LAYTON TREE CONSULTING, LLC

Trees & Construction Memo

To: Greg Arms
From: Bob Layton
CC: Scott McMillen
Date: March 20, 2025
Re: 7621 SE 22nd ST – Lot 1 Tree Protection

LOT 1 TREE PROTECTION PLAN

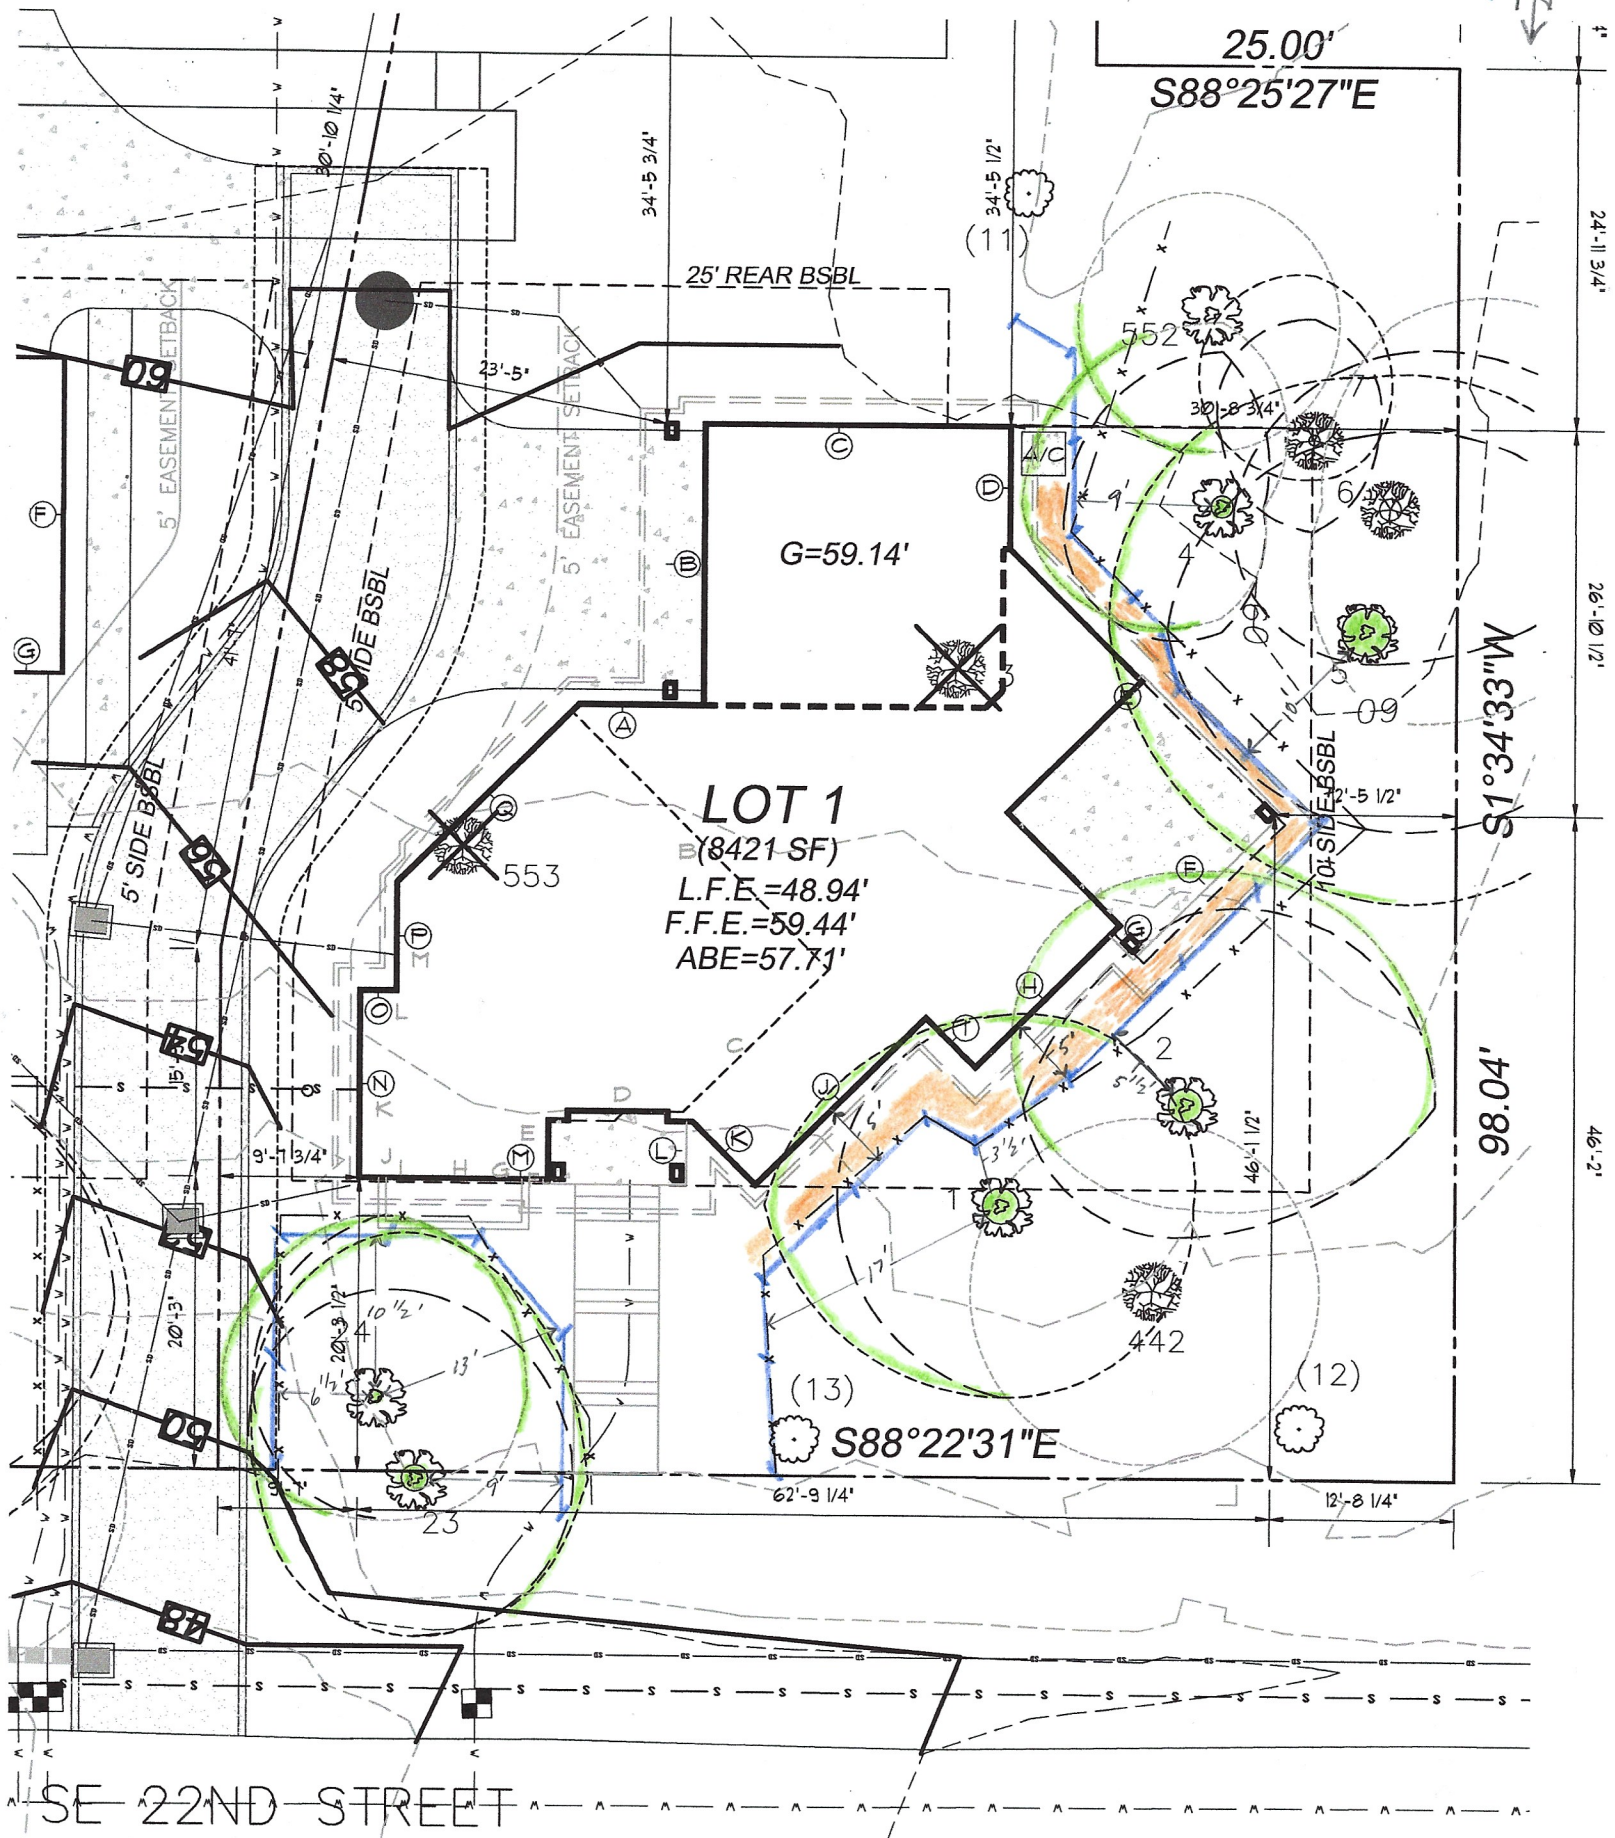
Excavation for the new foundation is within a proximity of the subject trees. Tree #2 is the closest at roughly 9-feet from the excavation limit. The area to be excavated for the house foundation has been previously disturbed by the demolition of the prior residence and the installation of utilities. The protection fence is currently positioned as shown on the approved plans.

The proposed impact is on the east side of the subject trees, which is ideal. The vast majority of structural roots will be on the southwest sides of the trees due to the region's prevailing wind direction. The species has good relative tolerance to construction impacts and can tolerate the anticipated root loss at the proposed distances from the tree trunks. Whether or not the excavation for the foundation is to a depth of 3-feet or 12-feet, the impact will be the same. All of the roots can be expected to be found within the top 2 to 3-feet of the ground surface. As long as the work is carried out diligently, all of the subject trees would be expected to remain viable or in their similar condition. The proposed work would not be expected to threaten the long-term health of the retained tree(s) per MICC19.10.080

To best protect the trees, lay out and mark on the ground the extent of excavation; and expand the tree protection fencing as shown on the attached plan. The tree protection fence shall be set at 5-feet from the new house walls to provide adequate construction clearance. The ground between the cut for the new foundation and protection fence shall be covered with a 4 to 6-inch layer of coarse wood/bark chip mulch or hog fuel to protect soils and surface roots during construction, per the attached map.
